Project	IEEE 802.16 Broadband Wireless Access Working Group < http://ieee802.org/16 >	
Title	Fast MSS-BS Data Flow Coordination for FBSS Support	
Date Submitted	2004-11-04	
Source(s)	Hang Zhang, Bill Gage, Shalini Periyalwar, Mo-Han Fong Nortel Networks	mhfong@nortelnetworks.com Tel: +1 613 765-8983 Fax: +1 613 765-6717
Re:	IEEE P802.16e/D5-2004	
Abstract	A fast signalling mechanism is introduced to identify the next information unit to be transmitted by a new anchor BS while the MSS is in FBSS handoff	
Purpose	Review and Adopt the suggested changes into P802.16e/D5	
Notice	This document has been prepared to assist IEEE 802.16. It is offered as a basis for discussion and is not binding on the contributing individual(s) or organization(s). The material in this document is subject to change in form and content after further study. The contributor(s) reserve(s) the right to add, amend or withdraw material contained herein.

6.3.2.1.4 FBSS SN Request Header

Figure 1: FBSS SN Request Header Format

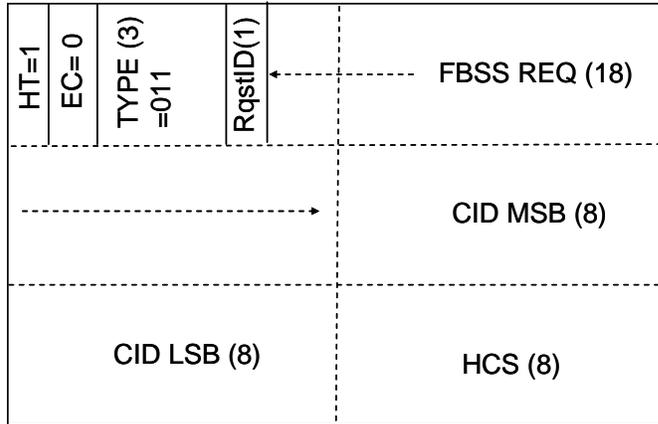
[Add a new section 6.3.2.1.4]

The FBSS SN Request Header shall be of the form illustrated in Figure 1. The FBSS SN subheader shall have the following properties:

- The length of the header shall always be 6 bytes
- The EC field shall be set to 0, indicating no encryption
- The CID shall indicate the basic connection for which the FBSS SN request is being made.

- The FBSS REQ field shall indicate the LSB of the next ARQ BSN or the virtual MAC SDU Sequence number for the active connections. The LSB of the ARQ BSN or virtual MAC SDU sequence number for each connection is provided. At most 3 SNs can be provided in each FBSS SN Request Header in numerical ascending order of the CID values of the connections with sequence number feedback enabled.

- The RqstID field may be used to indicate whether the FBSS SN header is the first or second of two consecutive FBSS SN headers, to accommodate up to 6 active connections. The fields of the FBSS SN Request header are defined in Table 1. Every header is encoded, starting with the HT and EC fields. The coding of these fields is such that the first byte of a MAC header shall never have the value of 0xFF. This prevents false detection of the stuff byte.
